2023 SWITCHGEAR UPGRADE RECORD DRAWINGS REDLINED FOR 2025 CHANGES	
W–058508–01A	PHYSICAL LAYOUT
W–058508–01B	BASE & SECTIONAL VIEW
W–058508–02	SINGLE LINE DIAGRAM
W–058508–03	NAMEPLATE DETAILS
W–058508–04A	GENERATOR 1 AC SCHEMATIC
W–058508–04B	GENERATOR 2 AC SCHEMATIC
W–058508–04C	GENERATOR 3 AC SCHEMATIC
W–058508–05A	FEEDER BREAKER/MASTER AC SCHEMATIC
W–058508–05B	FEEDER BREAKER/MASTER AC SCHEMATIC
W–058508–05C	VFD AC SCHEMATIC
W–058508–06A	GENERATOR 1 DC CONTROL SCHEMATIC
W–058508–06B	GENERATOR 2 DC CONTROL SCHEMATIC
W–058508–06C	GENERATOR 3 DC CONTROL SCHEMATIC
W–058508–07A	GENERATOR 1 DC CONTROL SCHEMATIC
W–058508–07B	GENERATOR 2 DC CONTROL SCHEMATIC
W–058508–07C	GENERATOR 3 DC CONTROL SCHEMATIC
W–058508–08A	GENERATOR 1 DC CONTROL SCHEMATIC
W–058508–08B	GENERATOR 2 DC CONTROL SCHEMATIC
W–058508–08C	GENERATOR 3 DC CONTROL SCHEMATIC
W–058508–09	MASTER DC CONTROL SCHEMATIC
W–058508–10	MASTER DC CONTROL SCHEMATIC

**KWETHLUK M&I 2025
IMPROVEMENTS PROJECT
ISSUED FOR CONSTRUCTION
MAY 2025**

ALASKA ENERGY AUTHORITY		
PROJECT: KWETHLUK M&I 2025 IMPROVEMENTS		
TITLE: SCHEDULE OF DRAWINGS		
 P.O. 111405, Anchorage, AK 99511 (907)349-0100	DRAWN BY: BCG	SCALE: NO SCALE
	DESIGNED BY: BCG	D

CUSTOMER ALASKA ENERGY AUTHORITY			
CUSTOMER JOB No. 21116			
DRAWN BY JRV	AUTH BY JRP	DATE 02-15-23	REV 3
DRAWING/FILE No. W-058508-06C			SHEET 6C

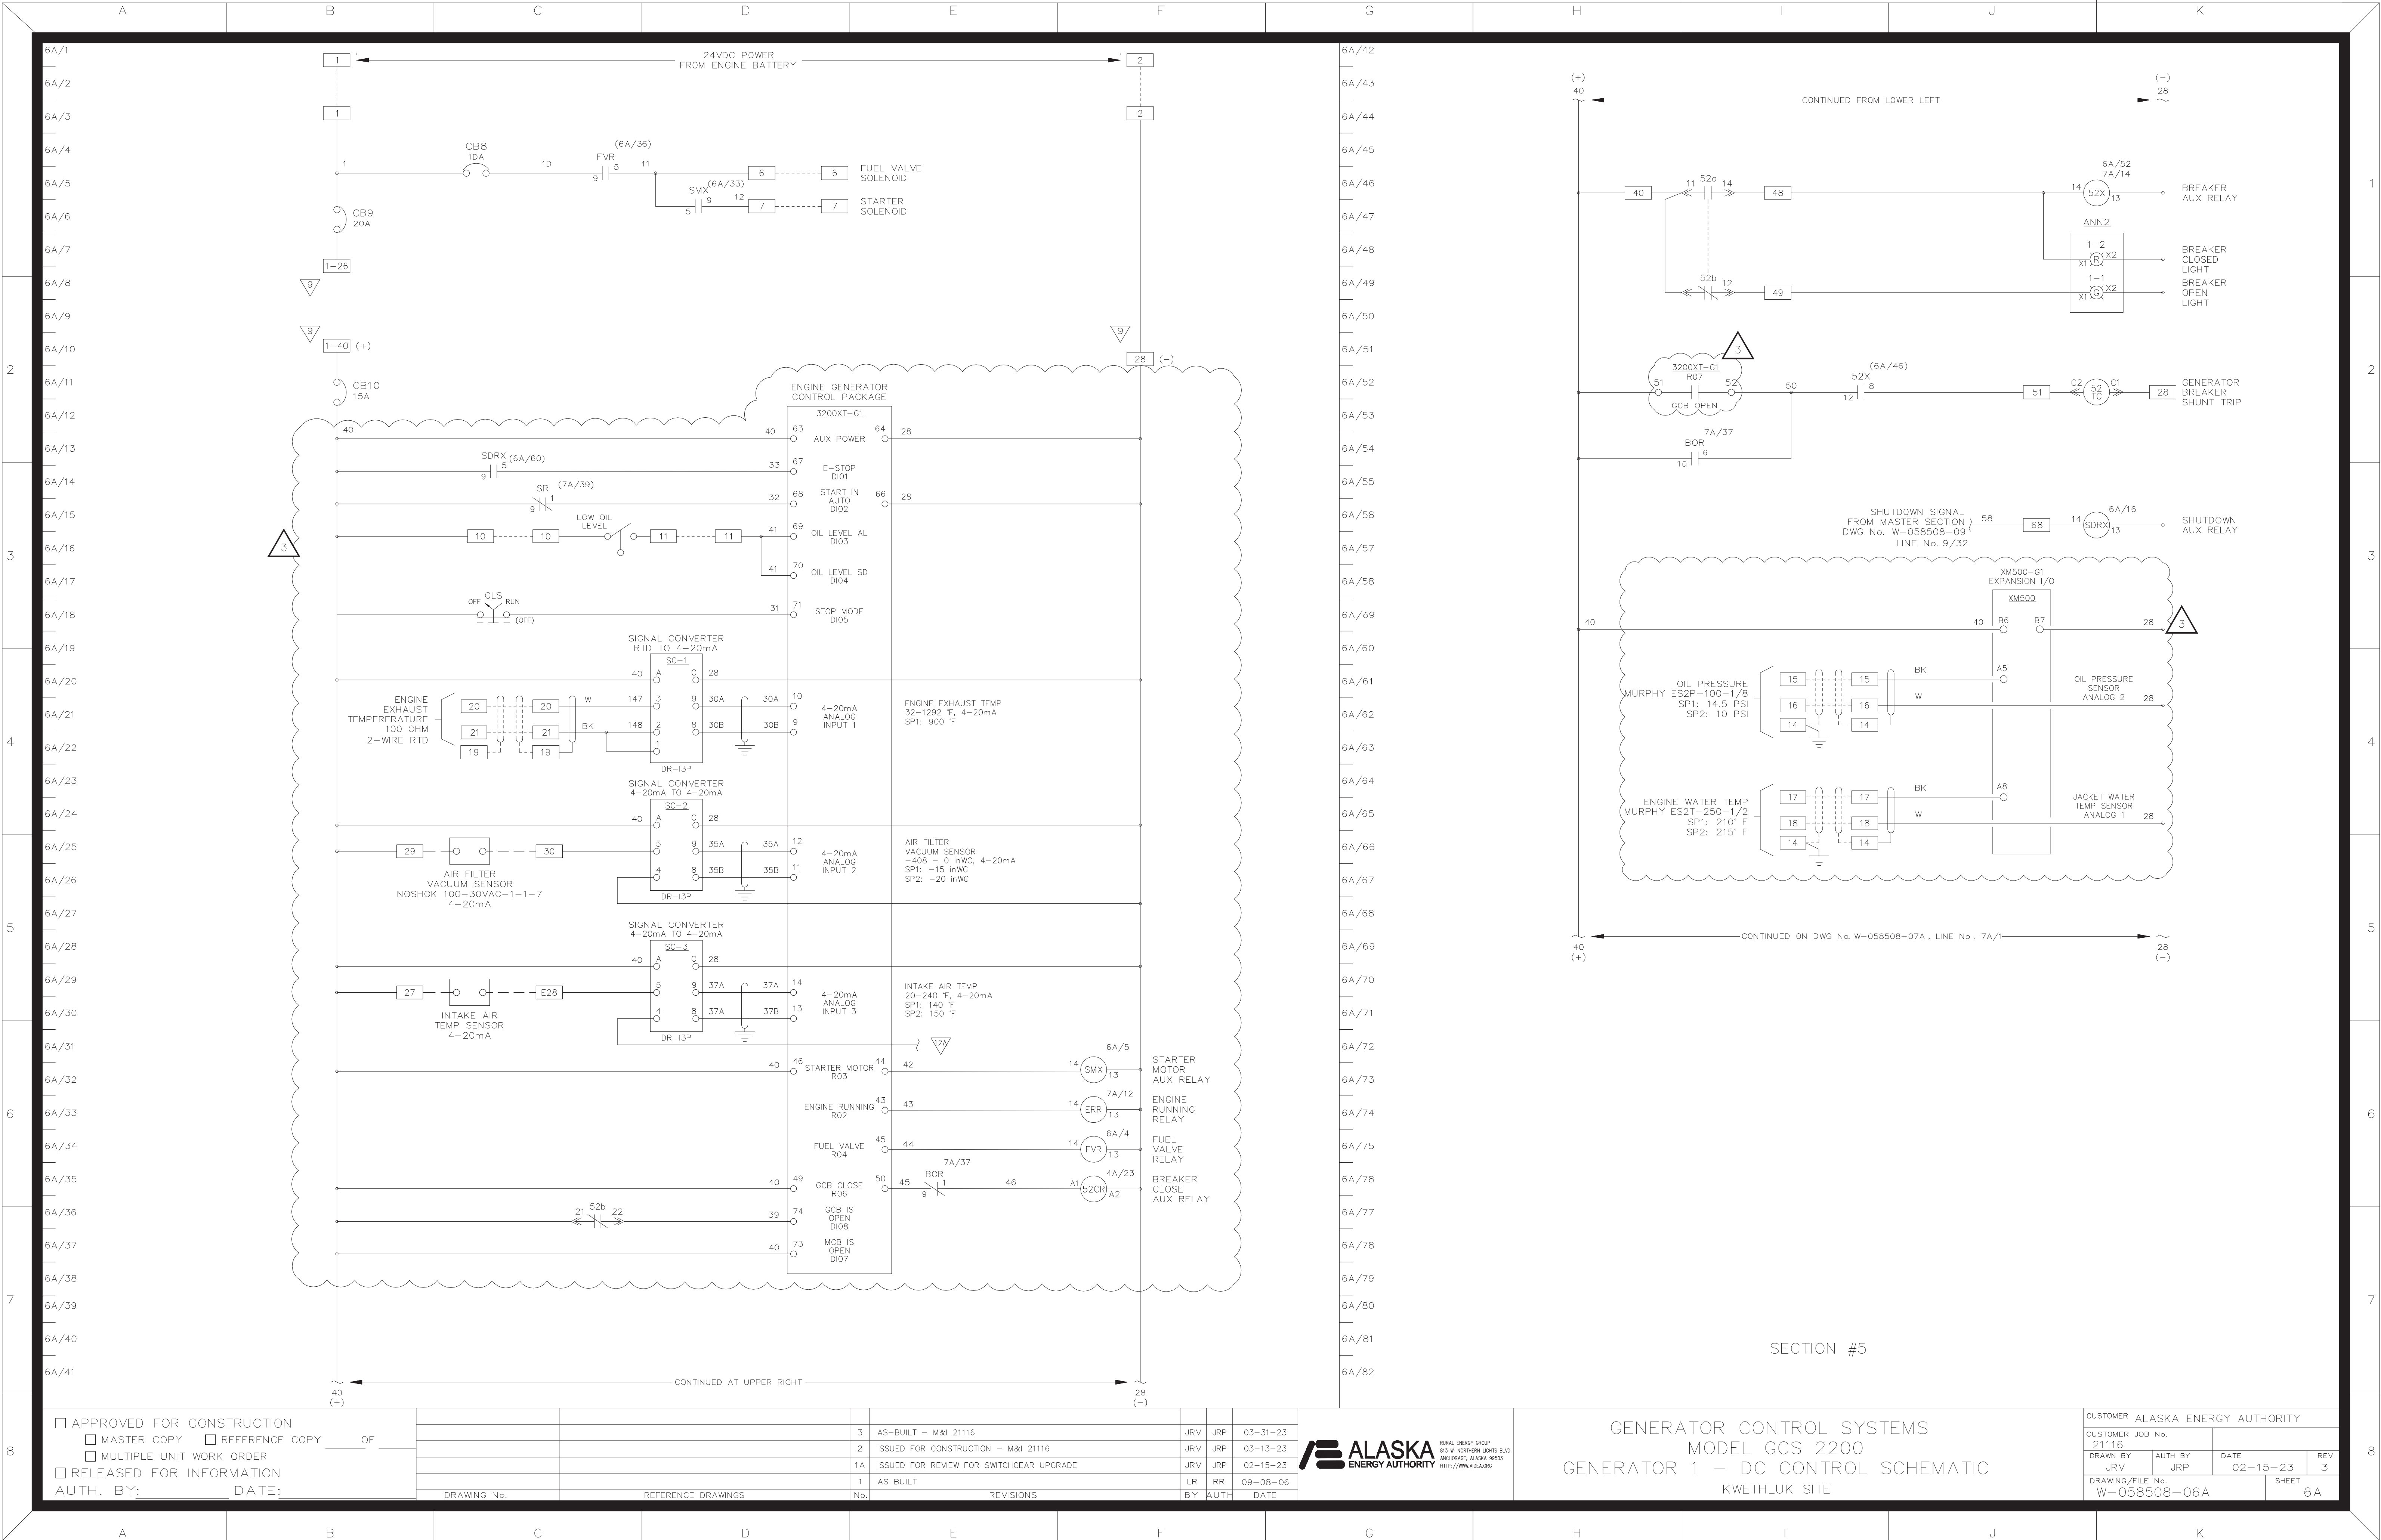
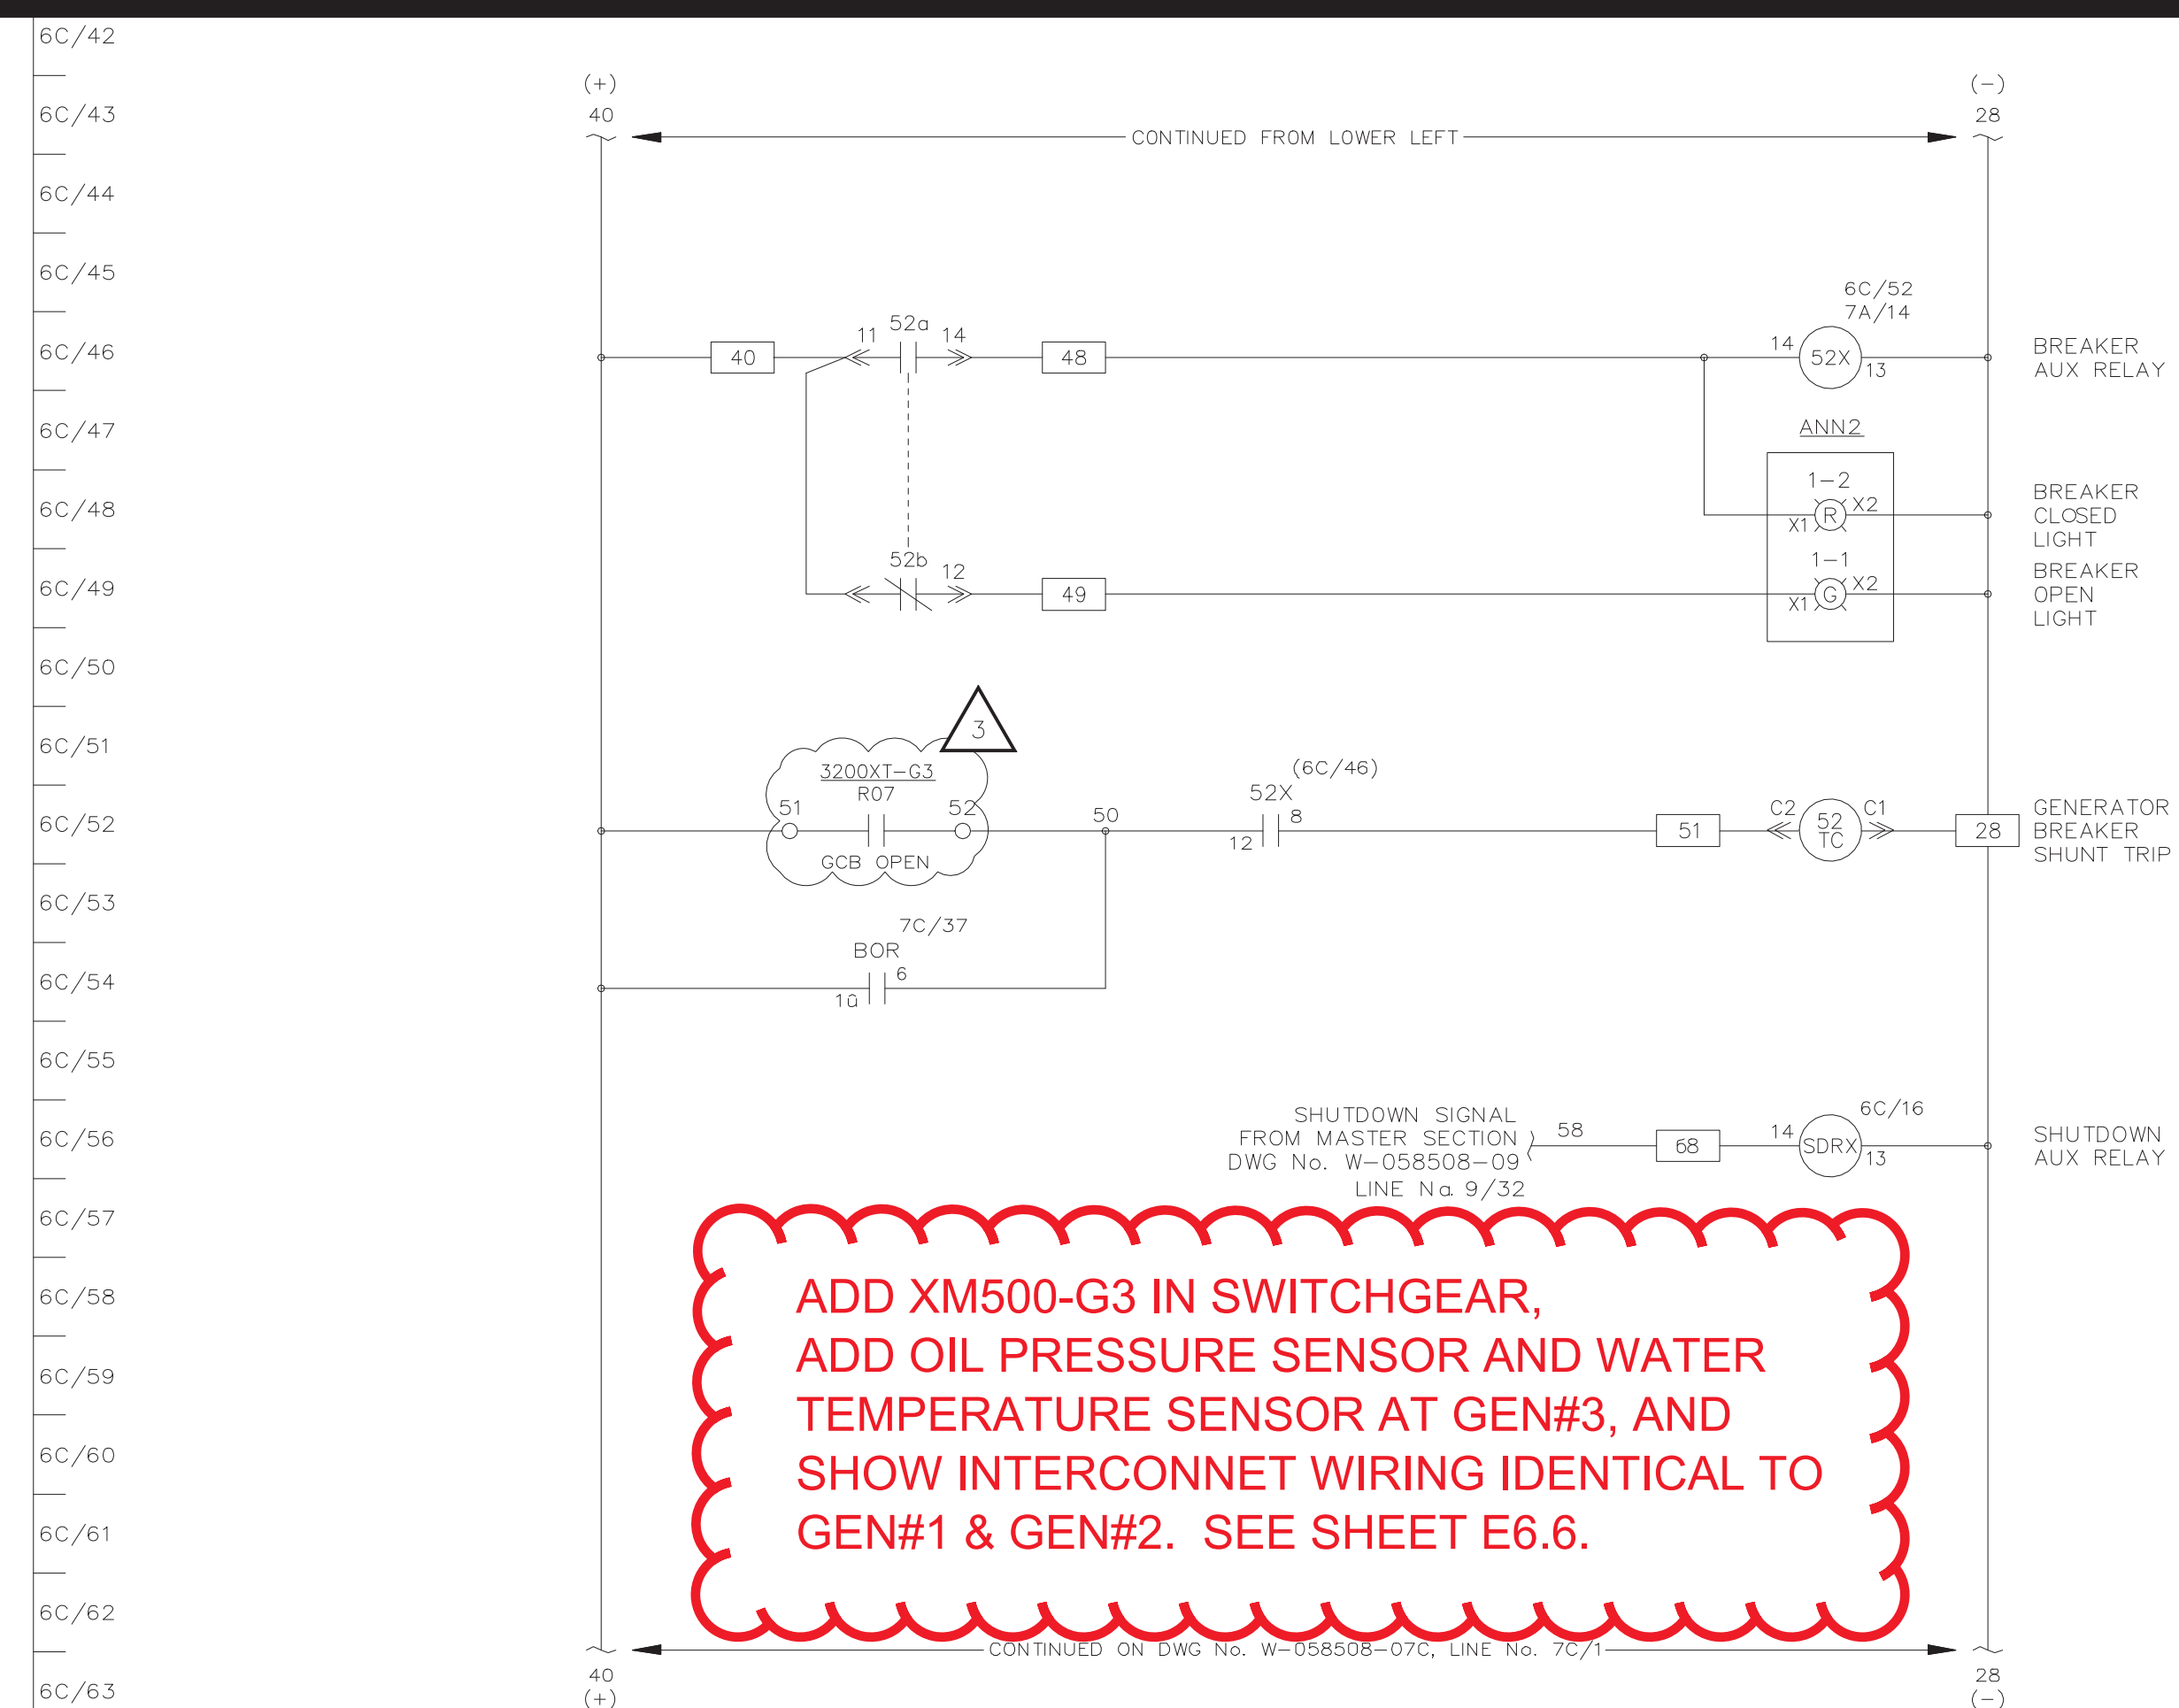
ADD XM500-G3 IN SWITCHGEAR,
ADD OIL PRESSURE SENSOR AND WATER
TEMPERATURE SENSOR AT GEN#3, AND
SHOW INTERCONNET WIRING IDENTICAL TO
GEN#1 & GEN#2. SEE SHEET E6.6.
